DATE: October 26, 2021
TO: Potential Respondents
FROM: Carrie Stoeckert—Senior Contract Administrator
SUBJECT: Questions #1
RFCSP763-22-149315CS
Research and Education Building 4th Floor Lab Renovation

**UNT HSC
RES 4TH FLOOR RENOVATION**
1055 MONTGOMERY ST FORT WORTH, TX 76107

ADDENDUM NO. [01]

PROJECT: UNTHSC RES 4th Floor Renovation
HE0698.2101.00

A400

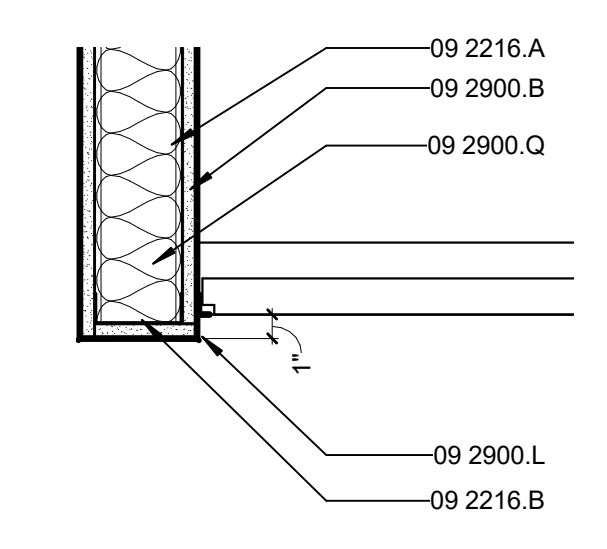
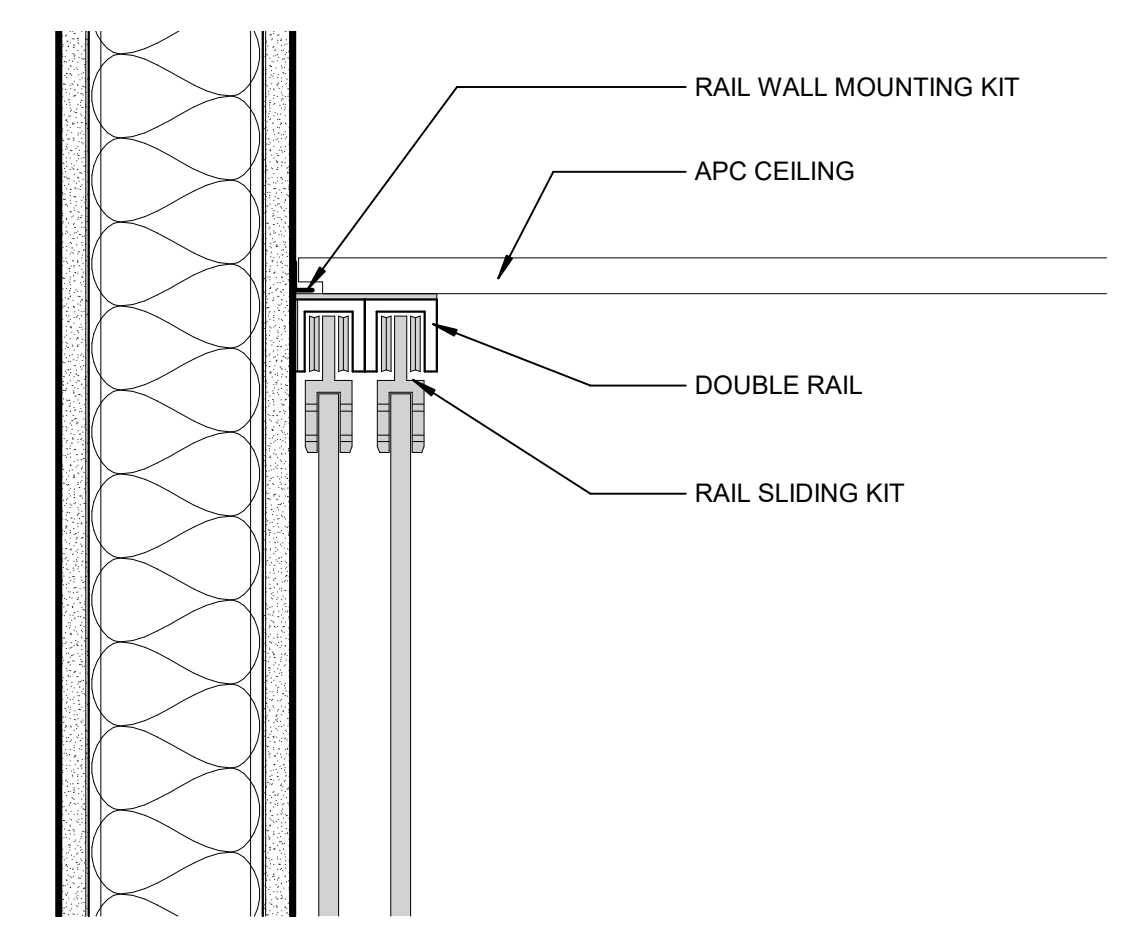
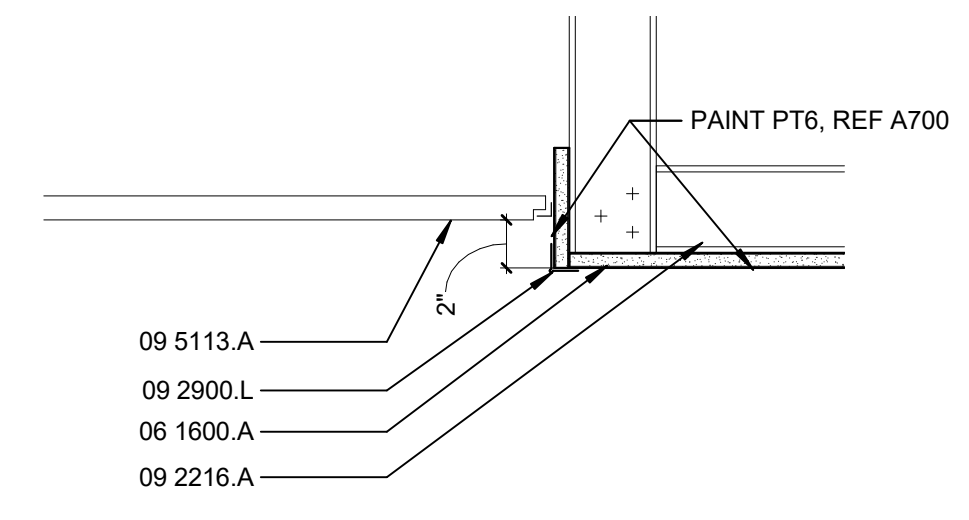
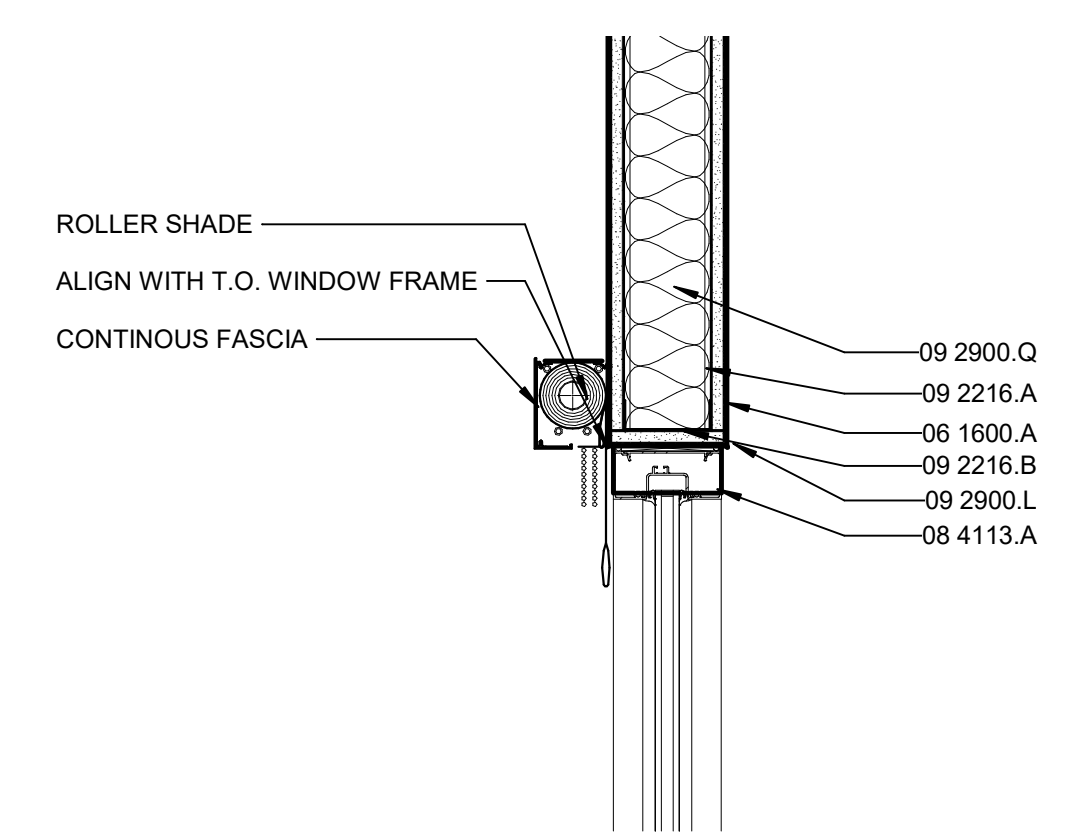
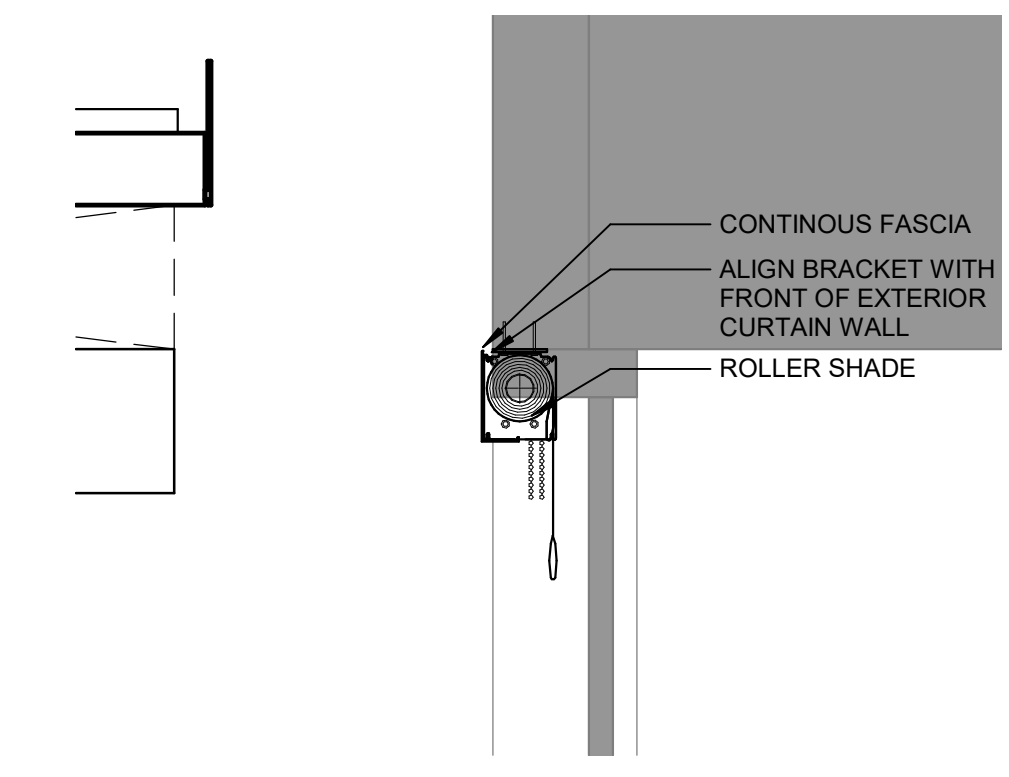
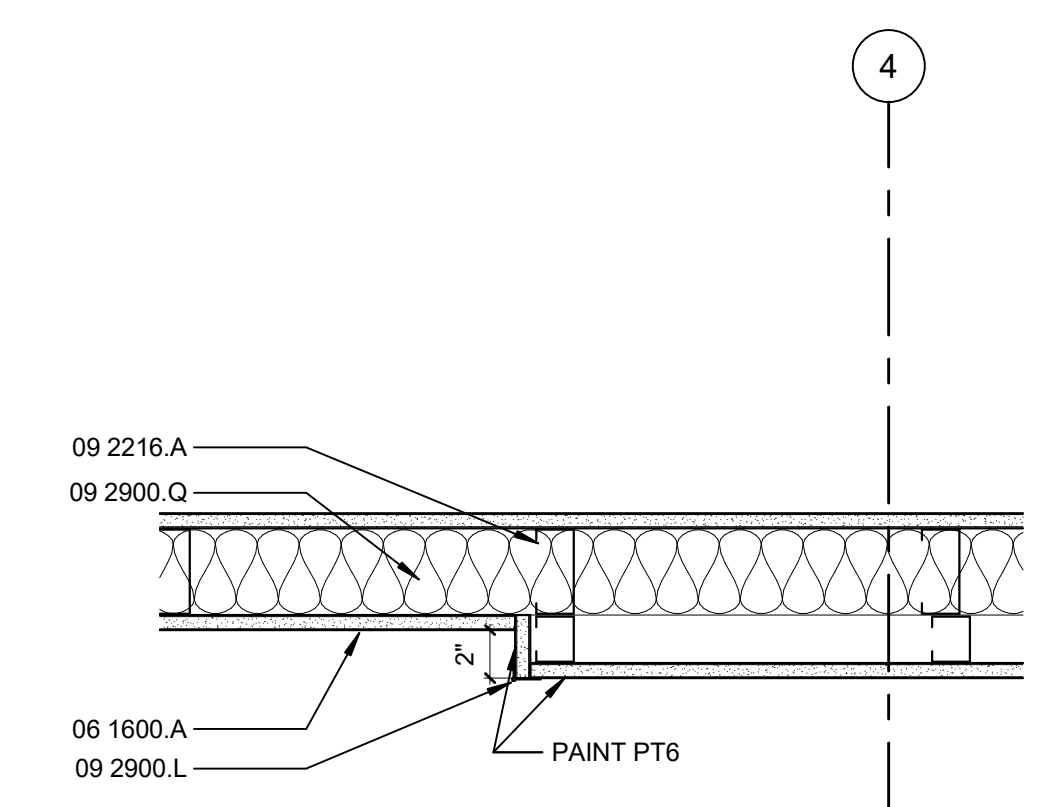
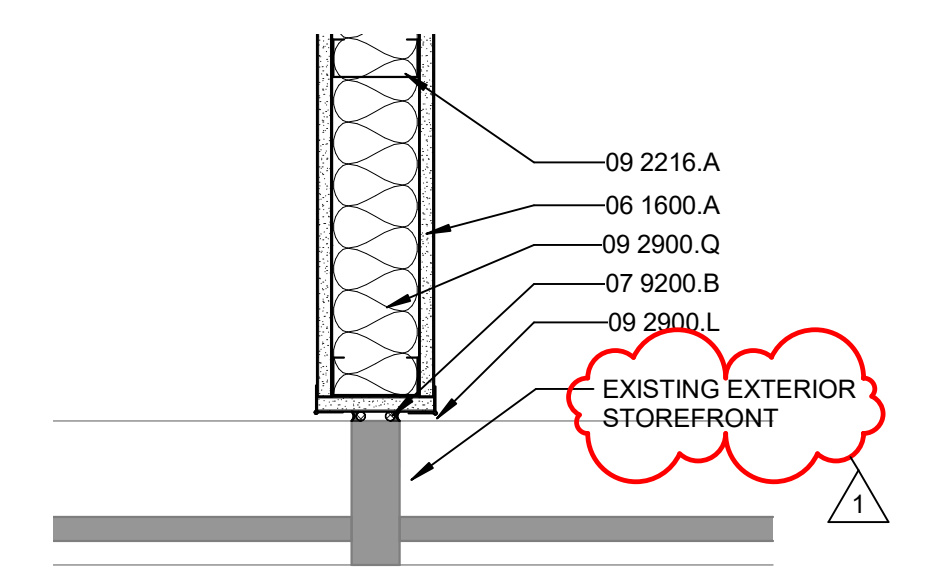
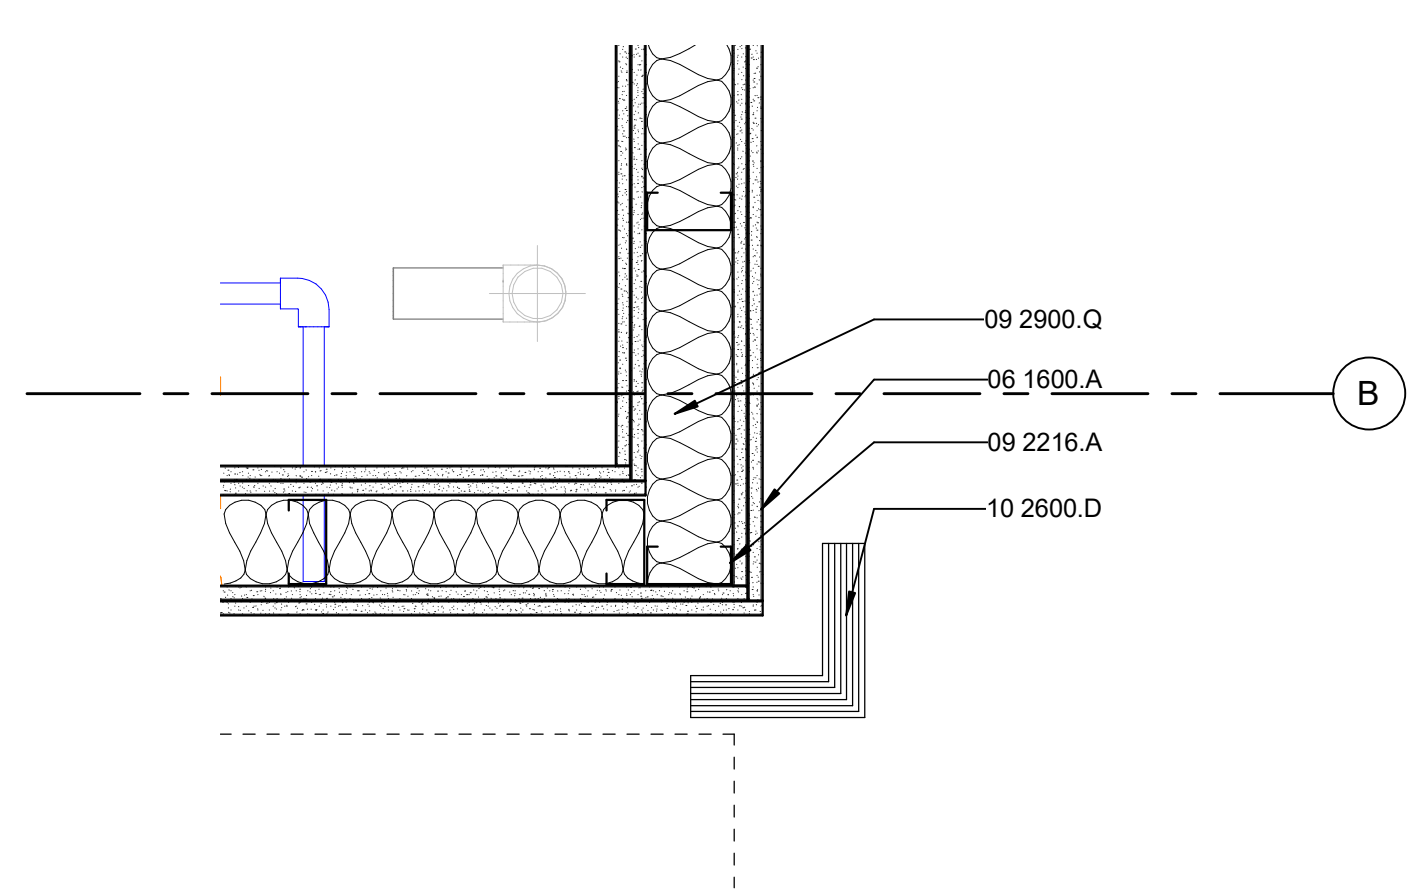
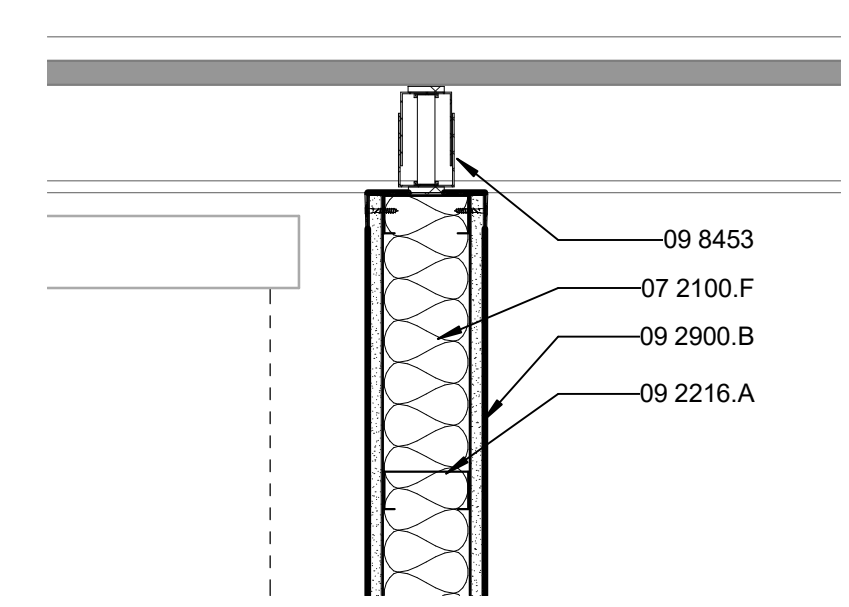
- 1.1 ***DRAWINGS REISSUED WITH MODIFICATIONS***
- 1.2 A400: Updated annotation for existing curtain wall to existing storefront

LEVEL 4 FINISH PLAN B1
1/8" = 1'-0"

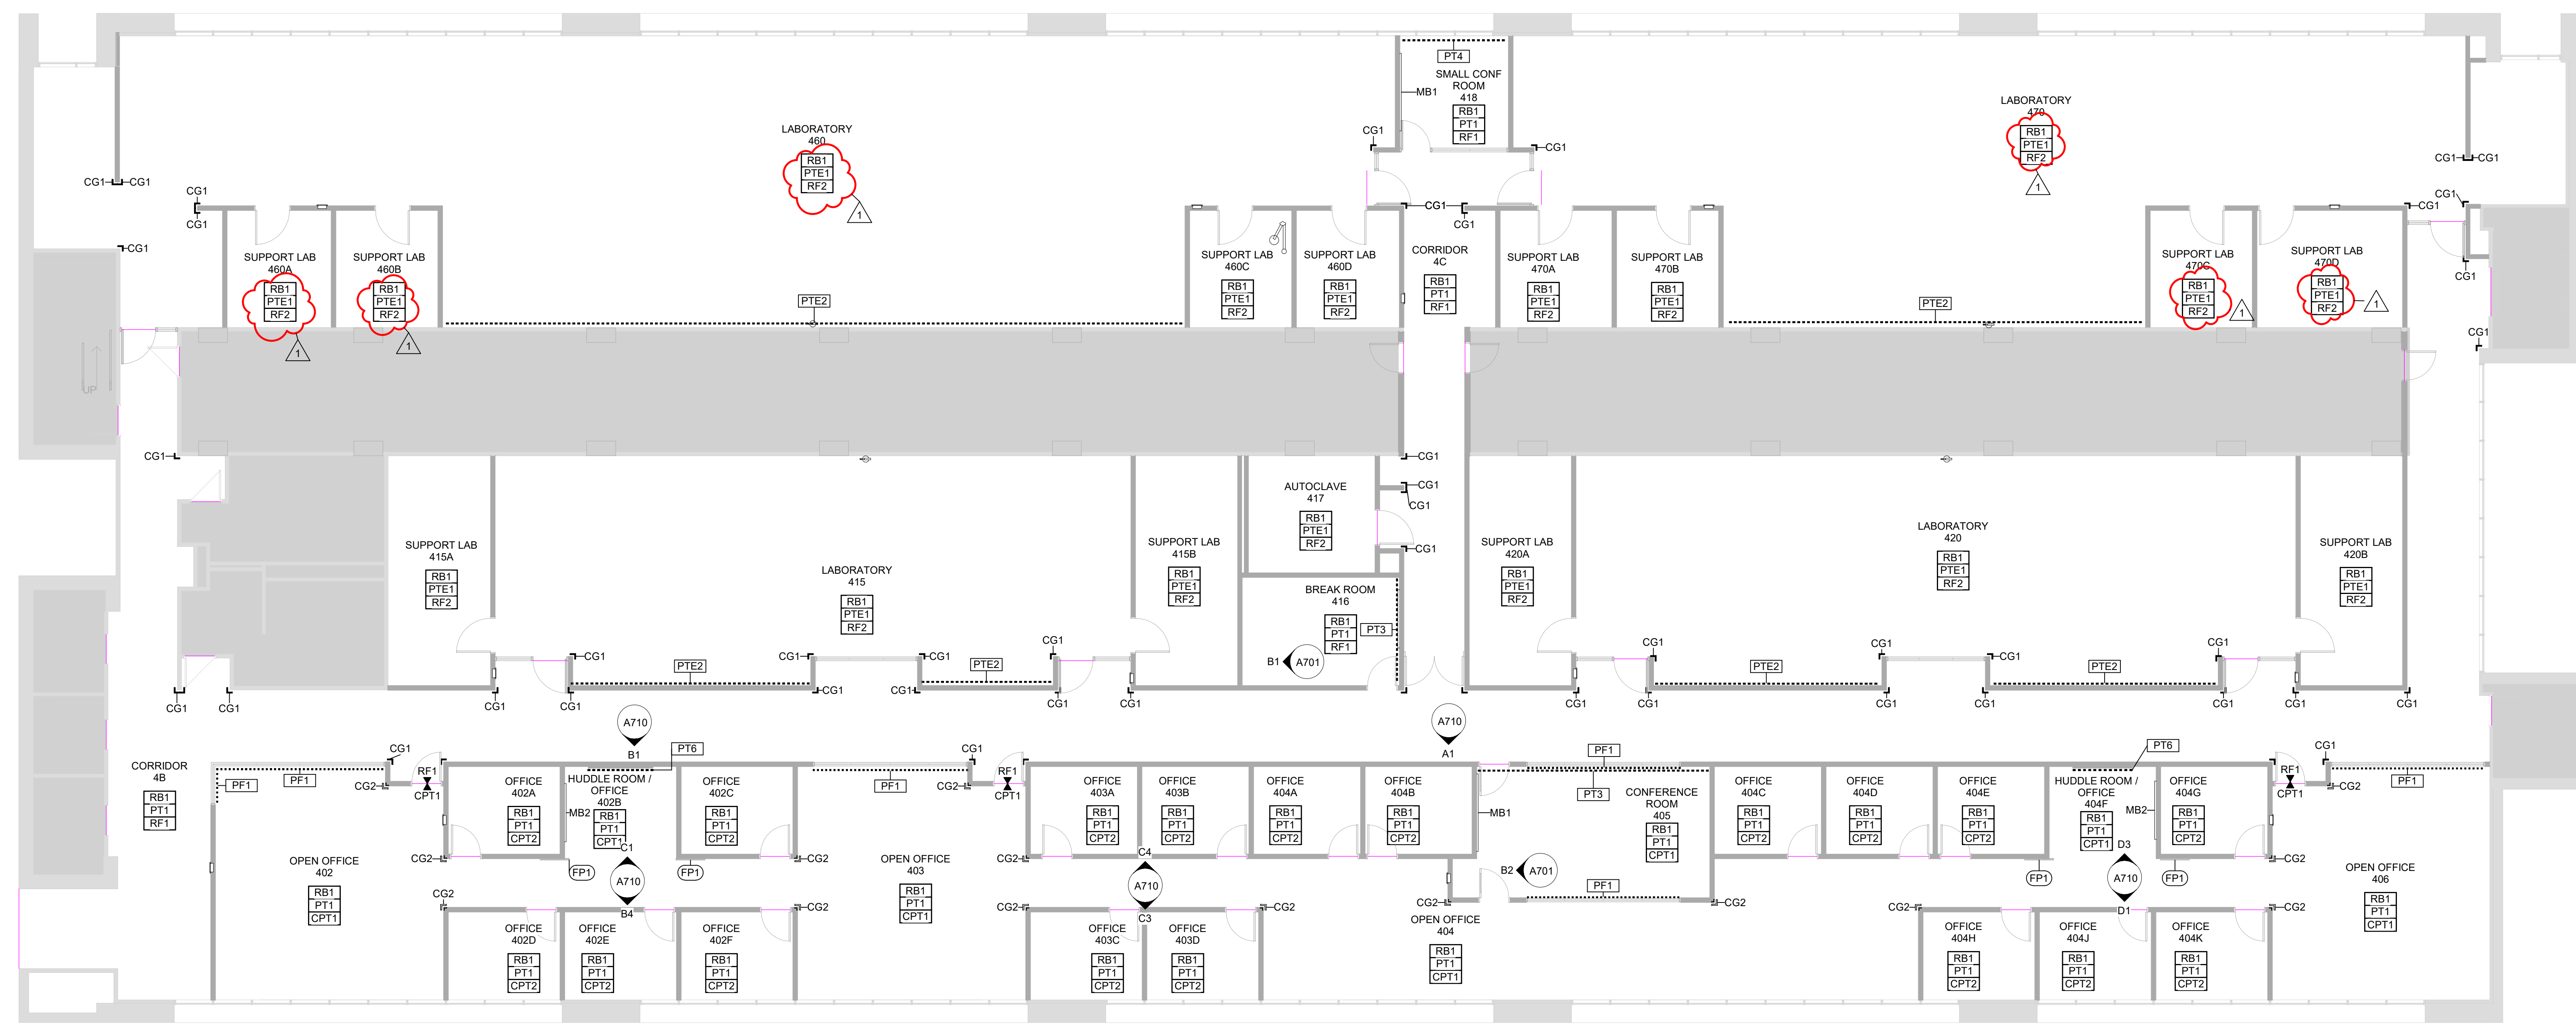
17. On sheet A700, Laboratory room 460 calls for RB2 as the floor type. Please provide a specification for this floor type. **Reference question #27 and addendum drawings.**

18. On sheet A700, Huddle Room 404F calls for D3T1 as the floor type. Please provide a specification for this floor type. **Flooring is to be CPT1, ref addendum drawings.**

26. Please confirm approximate dates that Abatement will be completed by the Owner. **End of December 2021.**
27. Reference drawing A700 - Rooms 460, 460A and 460B calls for RB-2. Is this meant to be RF-2? **This is meant to be RF-2. Ref addendum drawings for updated sheet**

A700: Updated flooring type in northern labs, adjusted marker board types to be consistent with manufacturers offerings
